SERVICE BULLETIN
#116
WARNING!!!!

SUBJECT: Leveling link assembly (16880-1) on VOE-36MHI

Directions for Service Bulletin #116

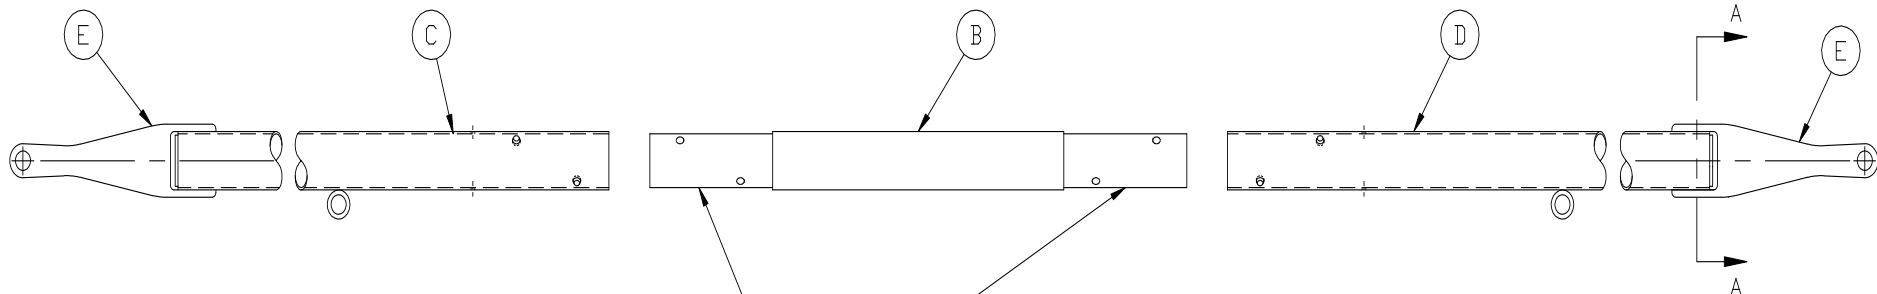
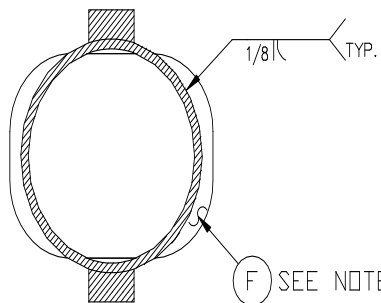
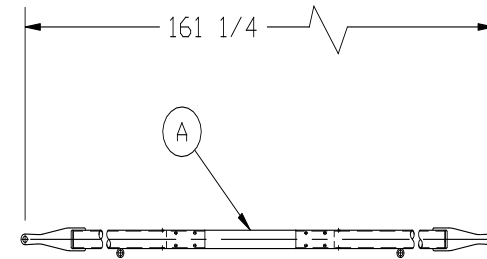
Time Manufacturing has received some reports that a few VOE-36MHI's are failing the periodic dielectric tests. Evidence has shown the failure is caused by moisture accumulating in the fiberglass link insulator, part number 16881-1. This occurrence seems to come about after the unit has been in service for several (5-6) years and the link exposed to excessive amounts of water.

A tube cover must be welded to the link ends to prevent water from enter the link tubes. In addition, the machined areas of the fiberglass insulator link must be sealed with urethane paint.

Also attached is drawing 32646-1, which details the components of the 16880-1 leveling link assembly. Time will furnish two complete assemblies of the 16880-1, leveling link assembly, to facilitate the execution of this bulletin. In addition, two (2) 32647-1’s, tube covers, are furnished for each aerial.

1. Remove the leveling link assembly, A, from the lower boom.
2. Dielectric test the link assembly
 - A. If the assembly passes dielectric
 1. Remove the fiberglass link insulator, B, from A. Please note that one link tube, C, is shorter than the other tube, D.
 2. Clean the machined areas of B to remove dirt, rust, etc.
 3. Seal the machined areas with a high quality urethane paint and set aside to dry
 4. Weld two (2) tube covers, F, one to each end of the link tubes, C & D, as detailed in view A-A. Paint as required.
 5. Reassemble link, insuring D & E are located the same as before disassembly, and install assembly back onto the lower boom.
 6. Dielectric test the complete unit
 - B. If the assembly fails dielectric
 1. Replace the failed link assembly with one supplied by Time Manufacturing or one that was reworked as described below.
 2. Dielectric test the complete unit

1. Remove the fiberglass link insulator, B, from A.
2. Place the insulator in a warm low humidity area for four days. This should dissipate any moisture that might have caused the failure. If an oven is available you can place the link in an oven and heat it to 200 degrees F. **Do not exceed 300 degrees F.**
3. Dielectric test the link again to insure it will pass
4. Clean the machined areas of B to remove dirt, rust, etc.
5. Seal the machined areas with a high quality urethane paint and set aside to dry
6. Weld two 32647-1, tube covers, F, one to each end of the link tubes, C & D, as detailed in view A-A on drawing 32646-1. Paint as required.
7. Reassemble link, insuring D & E are located the same as before disassembly

SEAL ALL MACHINED SURFACES WITH POLYURETHANE OR EQUIVLENT.

- NOTE:
- 1.) ITEM "F" IS TO BE WELDED ON BOTH ENDS TO SEAL OUT MOISTURE.
 - 2.) ITEM "A" PART NUMBER REFERENCES COMPLETED LEVELING LINK ASSEMBLY.
